Office Action Summary	Application No.	Applicant(s)
	10/758,697	EATON, HOMER <i>8M</i>
	Examiner John P. Fitzgerald	Art Unit 2856

DETAILED ACTION

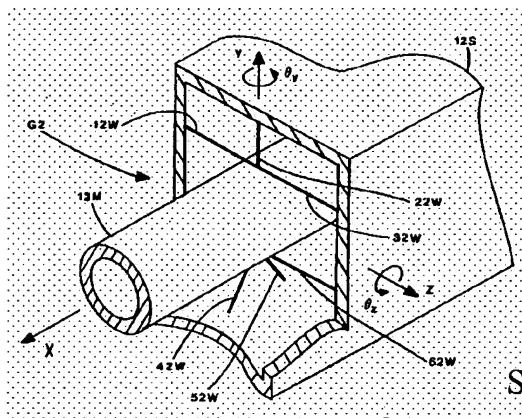
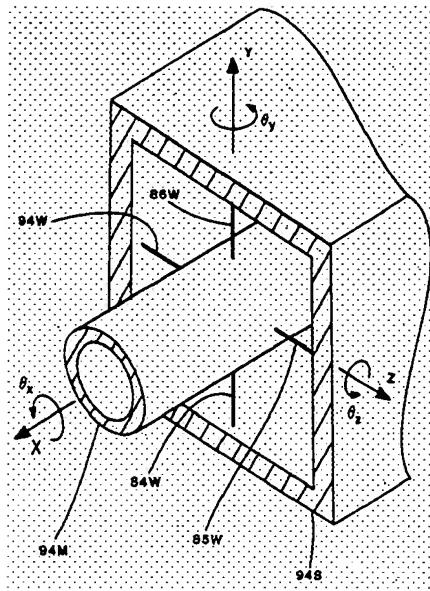
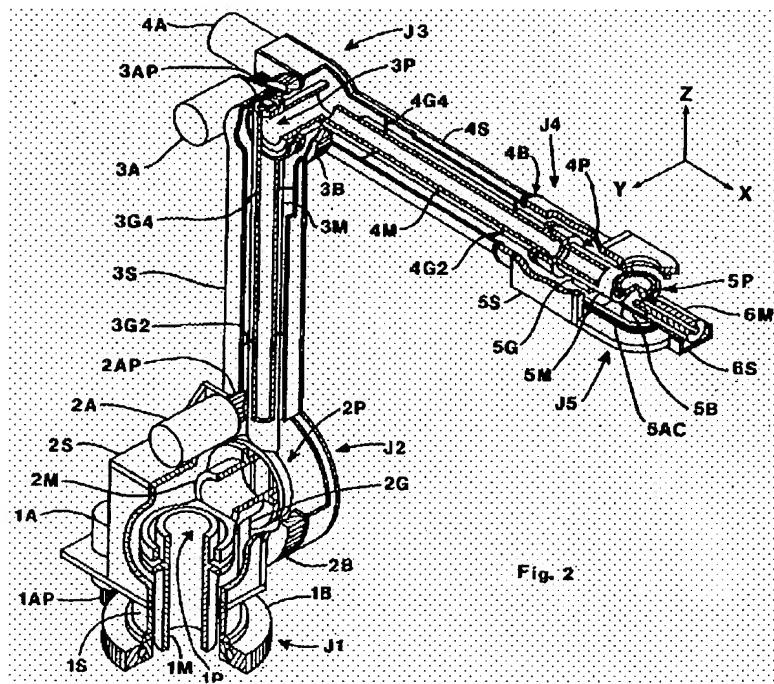
2. Claims 1, 6-15, 21-24, 31, 73 and 74 are rejected under 35 U.S.C. § 102(b) as being anticipated by US 4,676,002 to Slocum. Slocum teaches a positioning system (Figs. 1-20) and

method for positioning an articulated measuring arm having an articulated supporting arm (1S, 2S, 3S, 4S, 5S and 6S) comprising of plurality of jointedly interconnected support arm segments moveable about a plurality of axes; a plurality of compliant members (12W, 22W, 32W, 42W, 52W 62W, 84W, 85W, 94W) (see Figs. 3 and 4 below) positioned on the supporting arm; and an articulated measuring arm (1M, 2M, 3M, 4M, 5M and 6M) comprising a plurality of jointedly interconnected measuring arm segments capable of a plurality of degrees of freed of movement and supported by the compliant members wherein the compliant members provide a yielding characteristic (i.e. made of a deformable material, as recited in claim 13) as well as a constrained range of alignment (as recited in claim 23) between the articulated supporting arm and the articulated measuring arm allowing for a degree of angular offset between the support arm and the measuring arm segments (Slocum: col. 10, lines 15 to col. 11, line 7) (as recited in claims 1, 10, 11, 73 and 74) as well as positioning and supporting the measuring arm segments with the support segments (as recited in claims 9, 73 and 74); wherein the supporting arm and the measuring arm are co-axially aligned such that the movement of the supporting arm effectuates movement of the measuring arm (as recited in claims 6 & 7); wherein the support arm segments are shaped to partially contain the measuring arm segments (as recited in claim 8); wherein the compliant members can be chosen from magnetic levitation, air bearings (i.e. gas-filled chamber, as recited in claim 15), ball bearings, wire supports (i.e. metal/spring' material, as recited in claim 14) and wherein a controller is configured to direct the positioning of the supporting arm (Slocum: Fig. 18). As to claims 12, 21, 22, 24, 73 and 74, the reduction of mechanical stress (i.e. load sharing/reduction/transfer, thermal isolation (an air gap provides thermal isolation) and physical perturbations/vibrations are inherent features of the compliant members and, as such,

the compliant members disclosed by Slocum clearly meet these ‘physical’ limitations and will function accordingly.

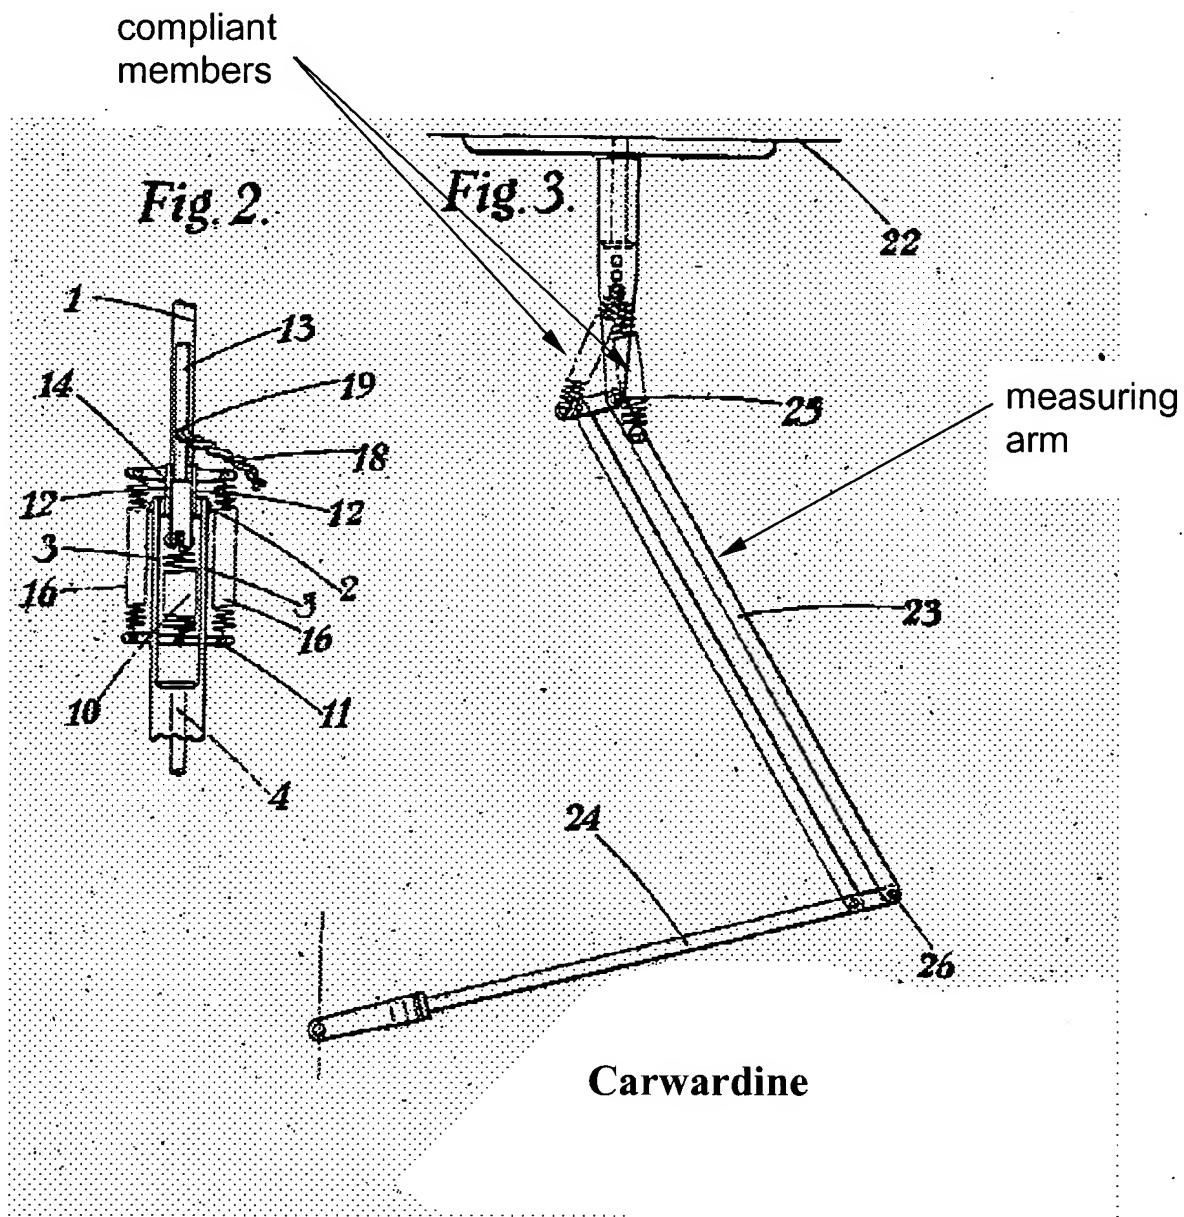
3. Claim 73 is rejected under 35 U.S.C. § 102(b) as being anticipated by US 2,076,446 to Carwardine. Carwardine discloses a method and apparatus for positioning an articulated

measuring arm (23) (see Fig. 3 below) including supporting the arm at a plurality of locations with compliant members (10, 16) to reduce mechanical stress on the arm (i.e. forces balanced and steady positioning of the arm).

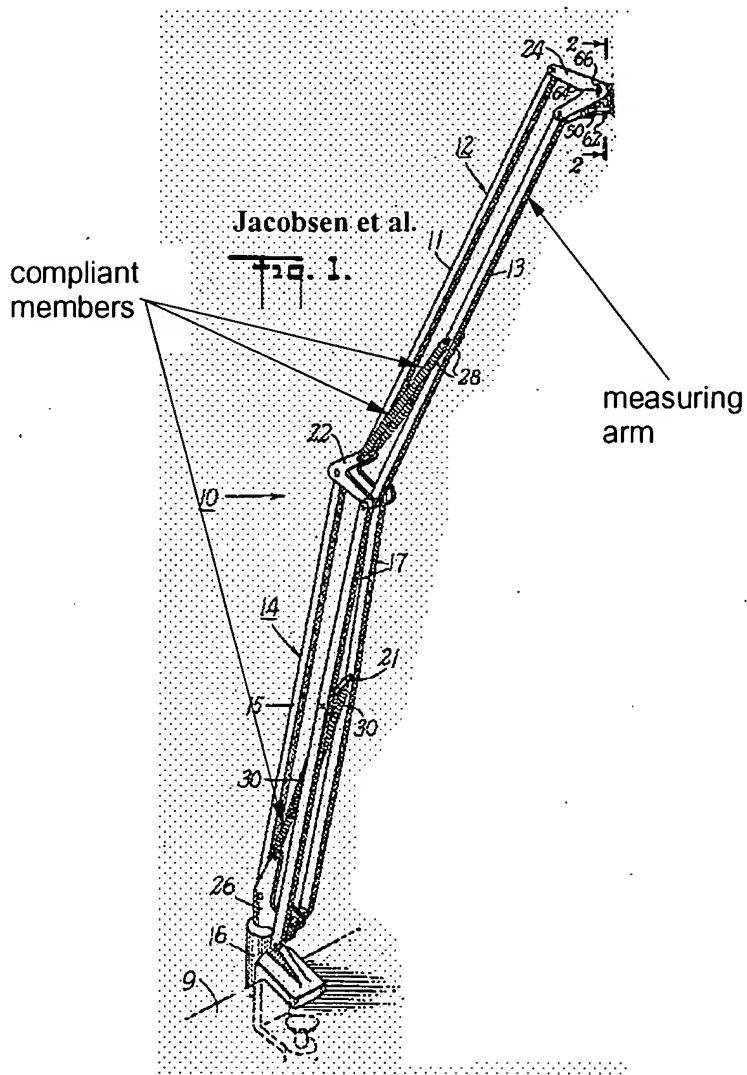
4. Claim 73 is rejected under 35 U.S.C. § 102(b) as being anticipated by US 2,787,434 to Jacobsen. Jacobsen discloses a method and apparatus for positioning an articulated measuring

arm (13) (see Fig. 1 below) including supporting the arm at a plurality of locations with compliant members (30, 26) to reduce mechanical stress on the arm (i.e. forces balanced and steady positioning of the arm).

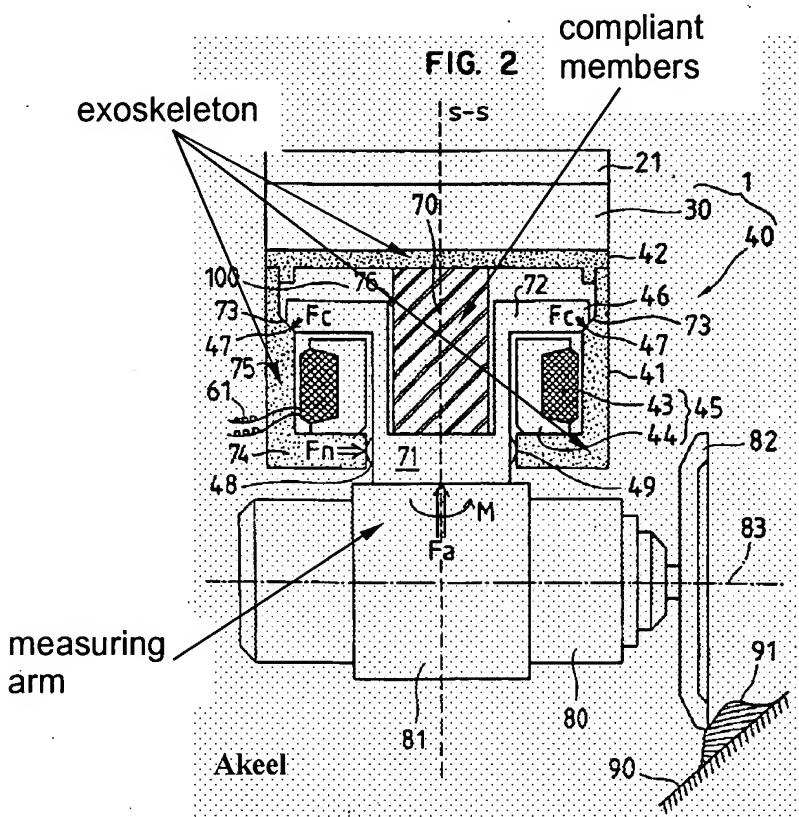
7. Claim 74 is rejected under 35 U.S.C. § 103(a) as being unpatentable over US 5,796,229 to Akeel. Akeel discloses a method and apparatus for damping external perturbations (i.e. reduction in vibrations and increased damping) encountered by an articulated measuring arm (71) (see Fig. 2 below) including supporting the arm at a plurality of locations with compliant member (70) that position at least a portion of the articulated the arm within an exoskeletal structure. Akeel discloses the claimed invention except for a plurality (i.e. multiple) elastic elements. It would have been obvious to one having ordinary skill in the art at the time the invention was made to employ multiple elastic elements, essentially splitting the compliant member (70) into a plurality of members, since it has been held that mere duplication of the essential working parts of a device involves only routine skill in the art. *St. Regis Paper Co. v. Bemis Co.*, 193 USPQ 8 (CA7 1977).
